Freeport-McMoRan Cobre Mining Company
P.O. Box 10
Bayard, NM 88023

Re: Freeport-McMoRan Cobre Mining Company -
Update to Closeout Plan for Permit No. GR002RE Revision 14-1 Cobre Haul Road

The updated CP, enclosed, is redlined where more detail was inserted to better describe the agreed-to reclamation design. The responses below describe specific details of the updated design. MMD's recommendations are in italics and Cobre's responses follow.

2014 Cobre Haul Road Closeout Plan

**FIGURE AR4 - FEBRUARY 17, 2016
GENERAL SECTIONS AND RECLAMATION
SLOPE DESCRIPTIONS - PROPOSED CHR**

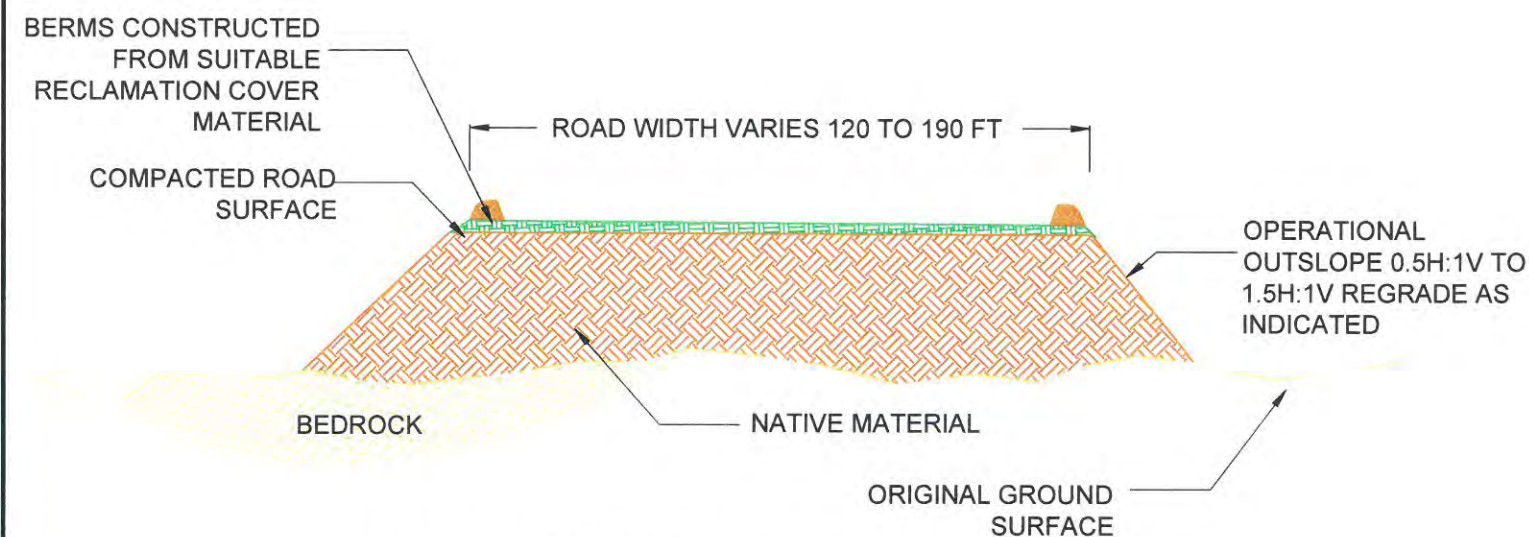
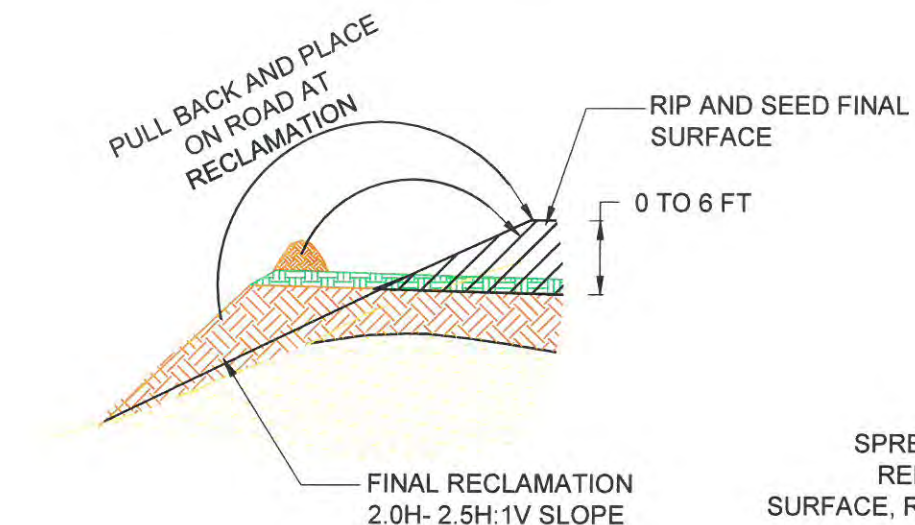
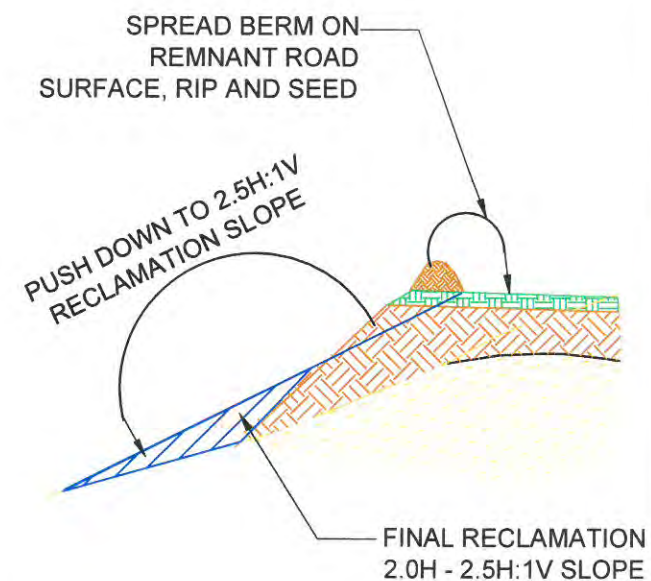
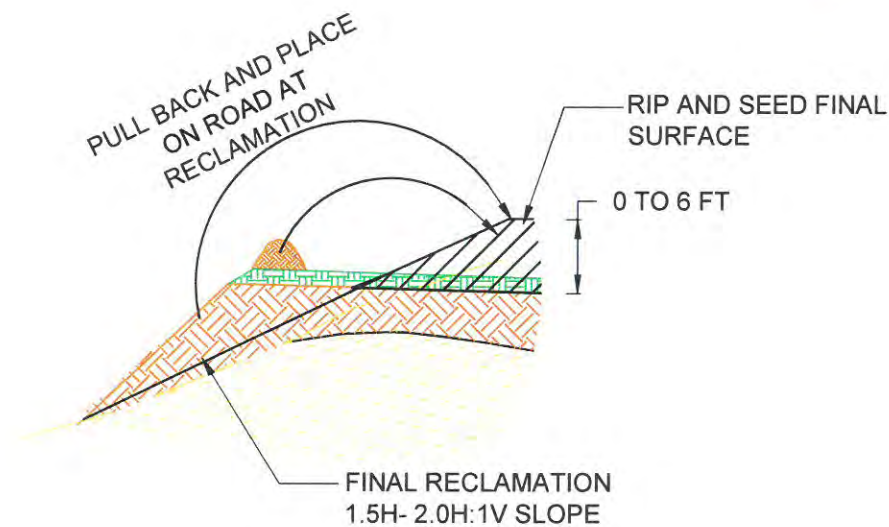
2. *The out slopes of the CHR should be reclaimed where it can be done to achieve, following closure, greater stability and better erosion control to meet vegetation standards.*

The updated CP reflects the recommendation of MMD that the CHR specifically be reclaimed at slopes other than angle of repose. Out slopes are pulled back or pushed down to the extent practicable based upon surrounding topography while preserving storm water management features such as sediment traps and culverts for the remaining ephemeral drainages. The updated design shows the remaining two-track service road relocated to the east in order to facilitate regrading of the out slopes. The CP includes additional tables detailing the volume estimates used to support the new reclamation cost estimate.

FIGURE A11R - FEBRUARY 17, 2016
RECLAIMED PROPOSED COBRE HAUL ROAD CONTOURS, SHEET 5

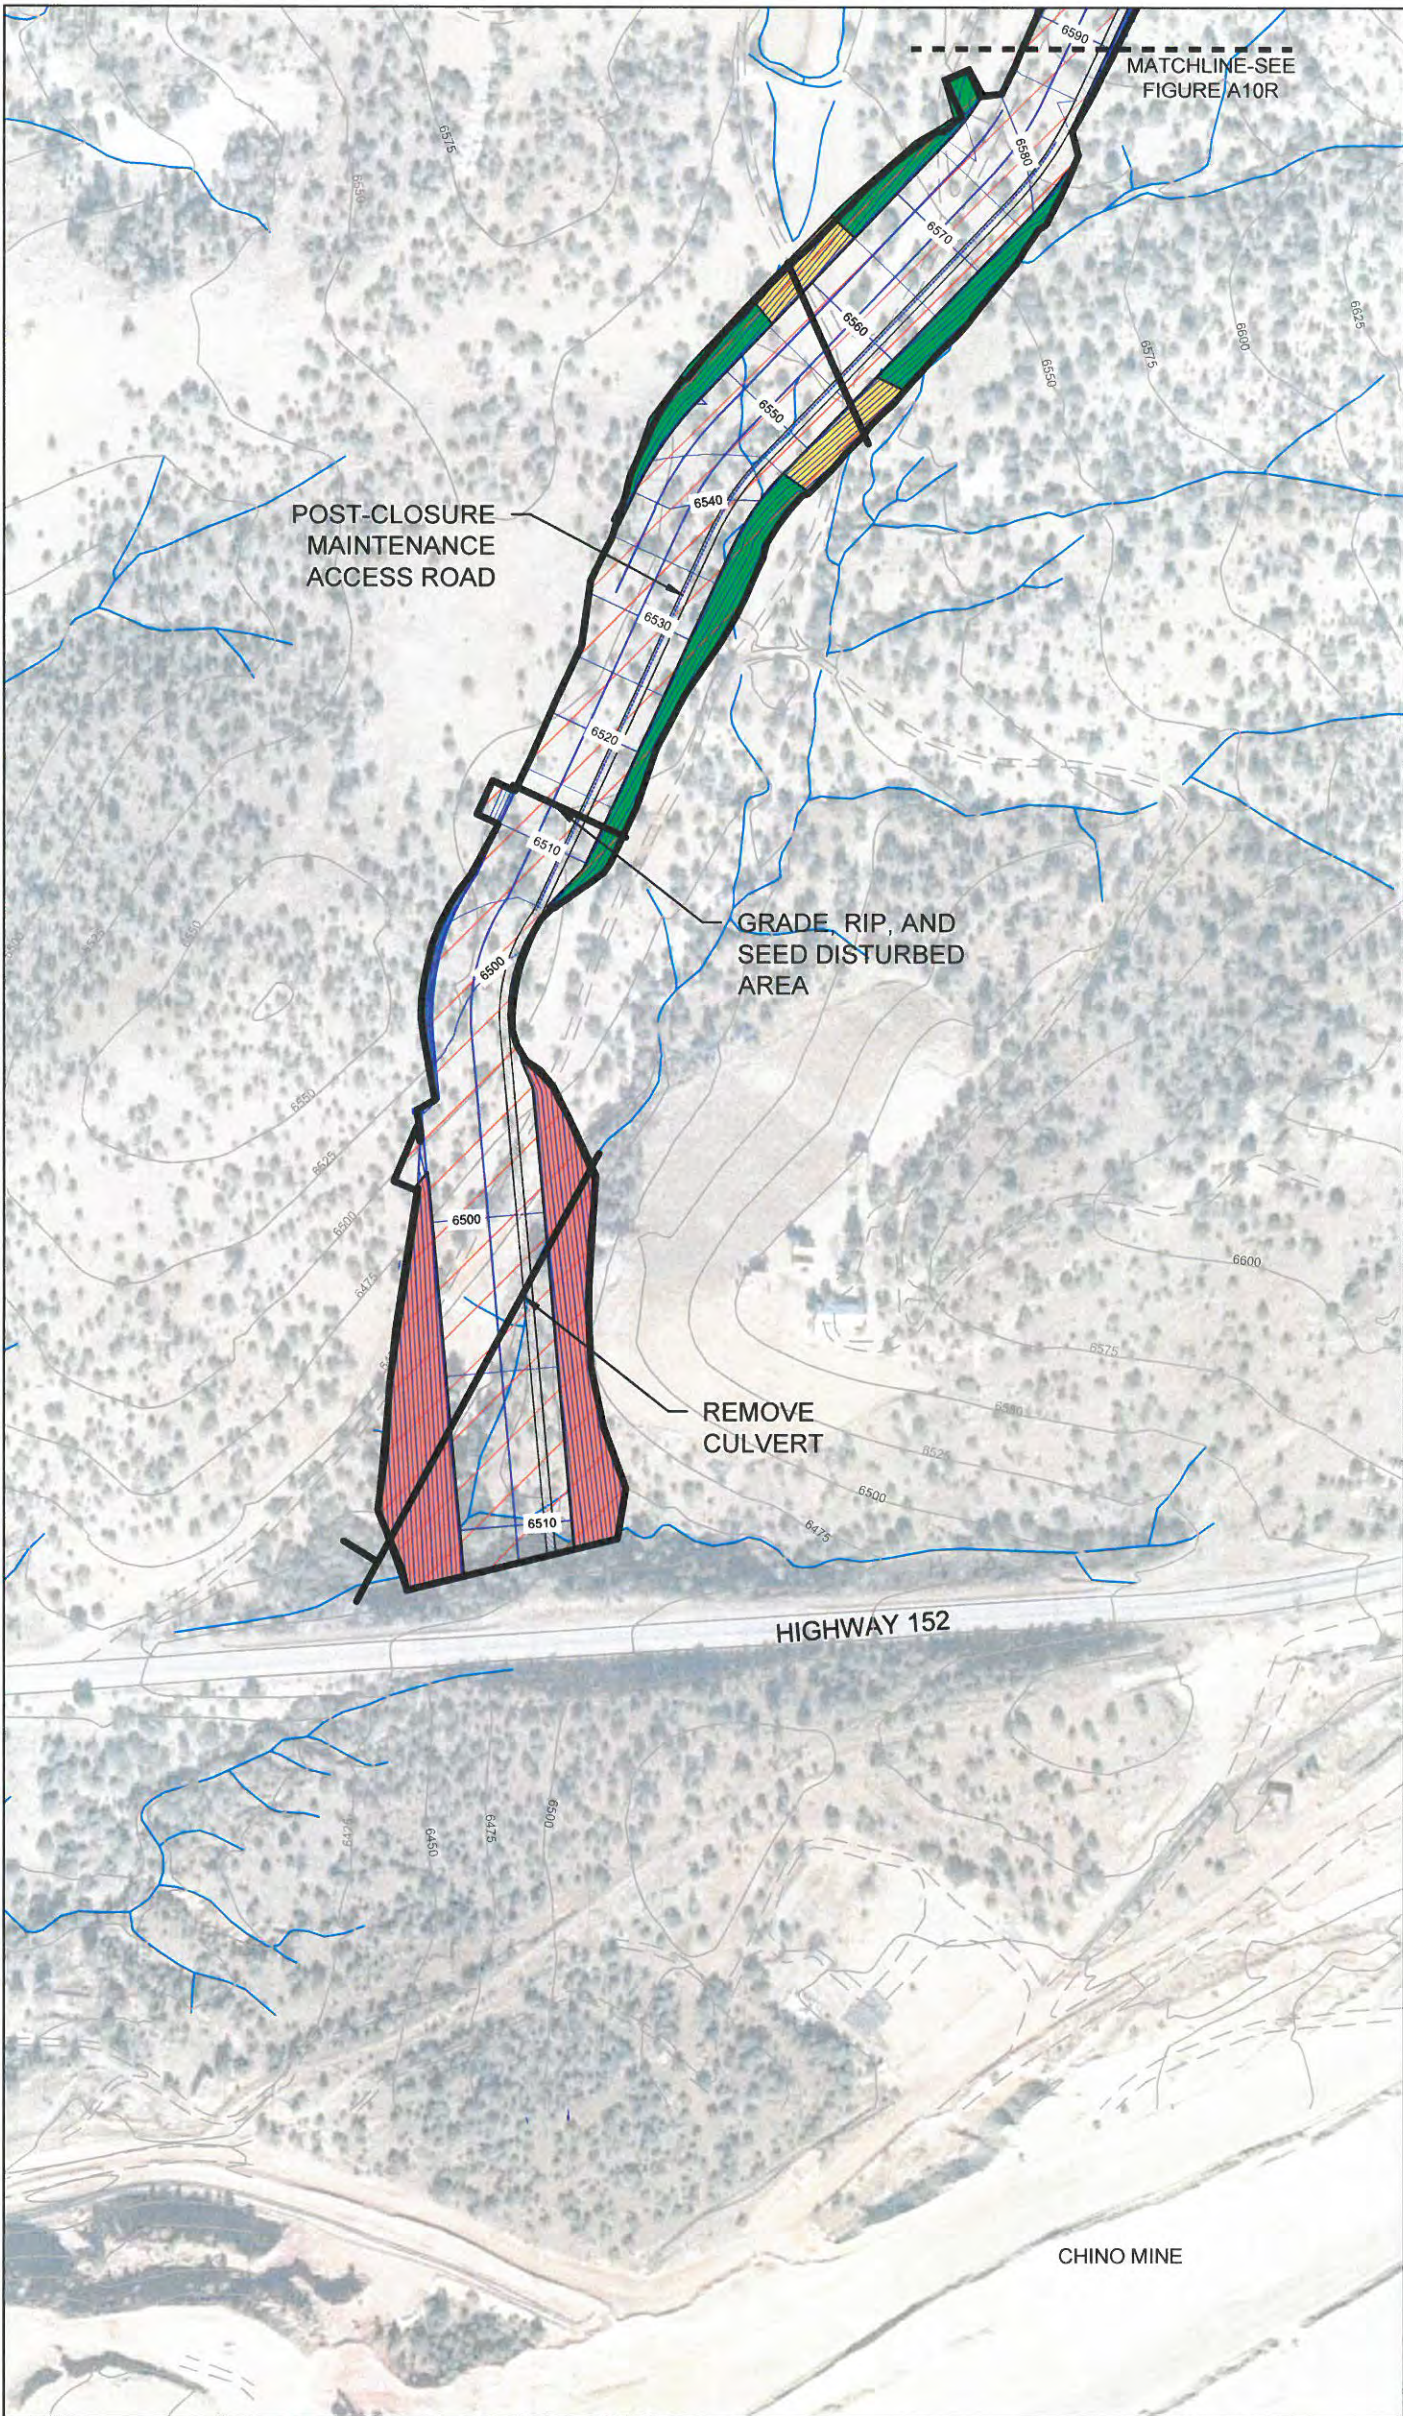
1. *Provide an estimate for removing culverts where practicable.*

Cobre will also remove an 880 foot culvert on the south end of the CHR because the fill material can be efficiently and practically used at other reclamation sites and removal of this culvert will not impair use of the remaining two-track service road. The cost to remove this culvert is included in the updated CP.
